AUTHORIZATION TO CONDUCT STREAM ALTERATION ACTIVITIES

Project Number: SA-3-105 -2016

Applicant Name: Town of Williamstown

Project Location Williamstown Wastewater Treatment Site Email: williamstownvt.org

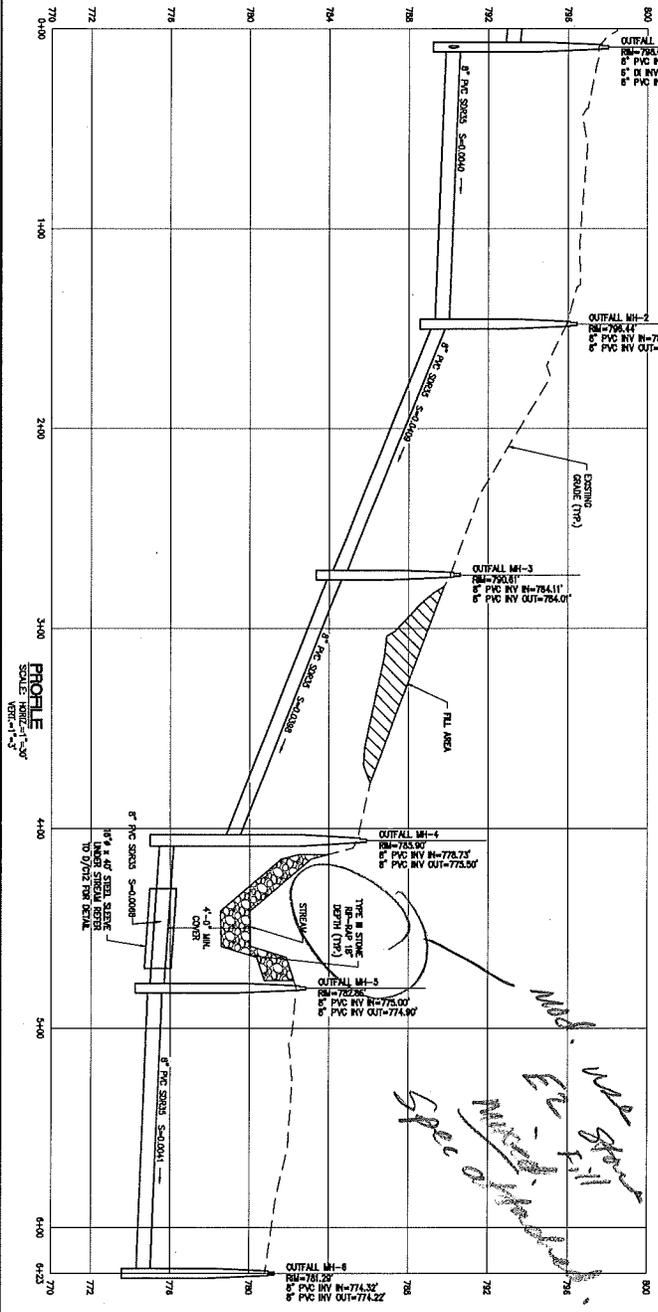
Handwritten notes:
 Note: Elevation of structure is 774.00'
 Spec. 1000-1000-1000

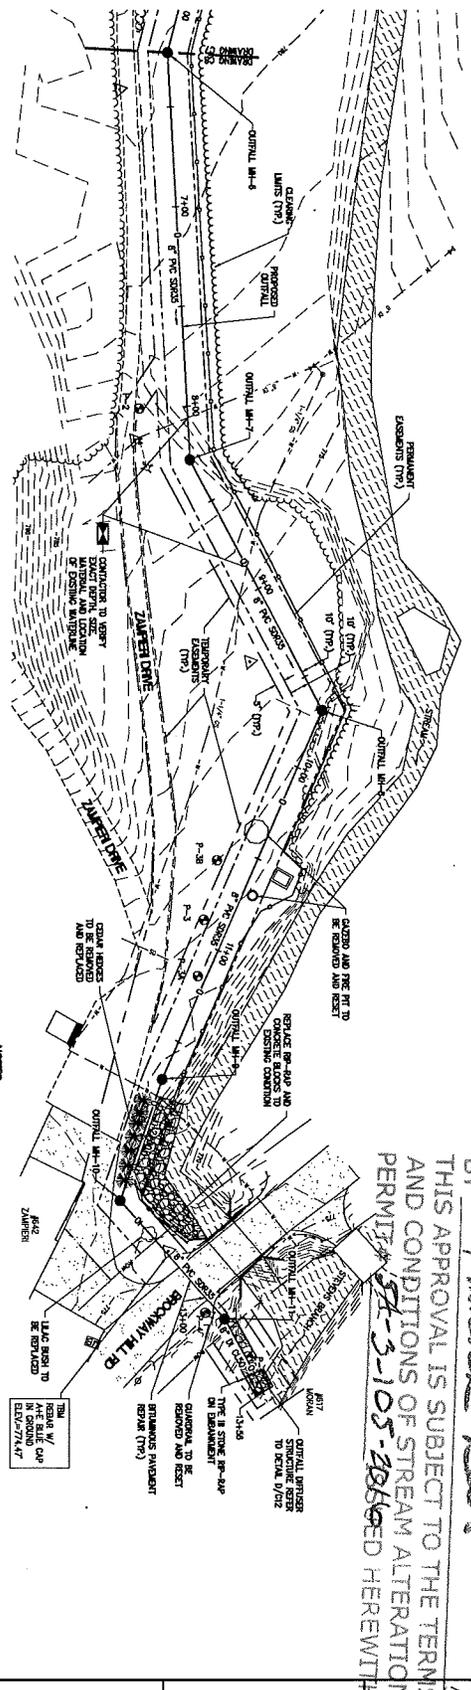
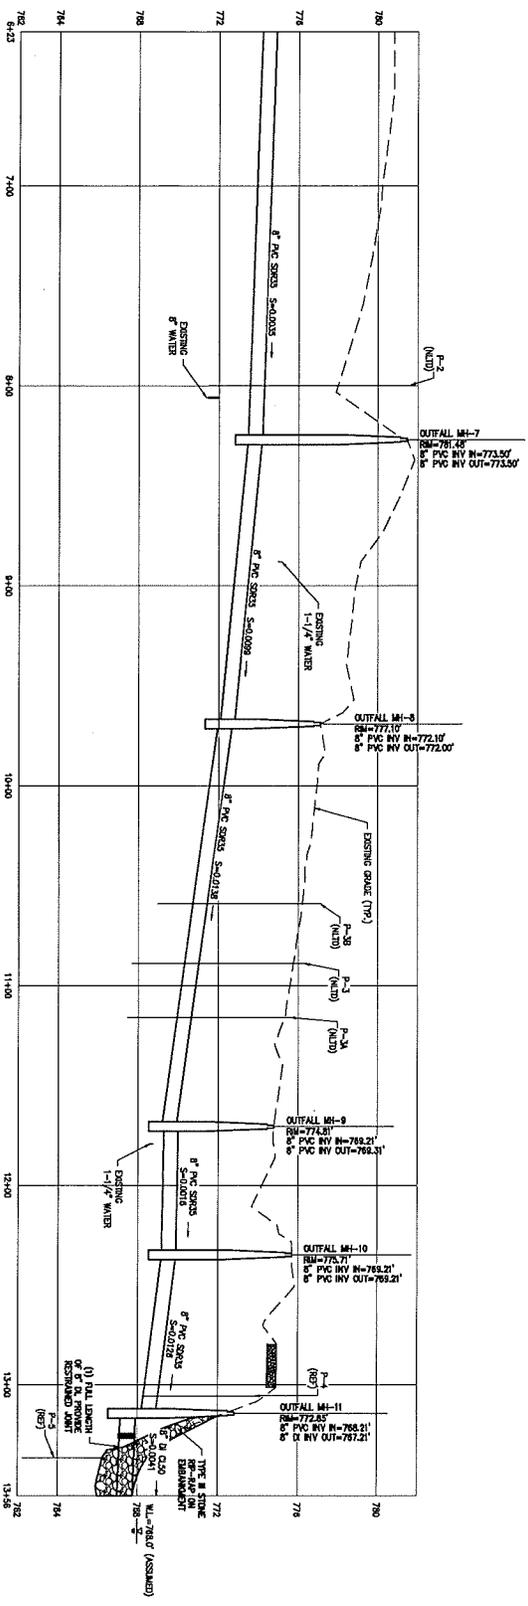
- Instream construction should be limited to the period of June 1 – Oct 1 to protect wild brook trout reproduction within the Stevens Branch and its tributary.
- The restoration of the stream channel where pipeline crossings are proposed should include a gradation of materials, including fines, as required for bed armor treatments. Currently the proposal calls for Type III stone. Streambed and channel roughness characteristics should match adjacent sections of the unaltered stream upon completion.
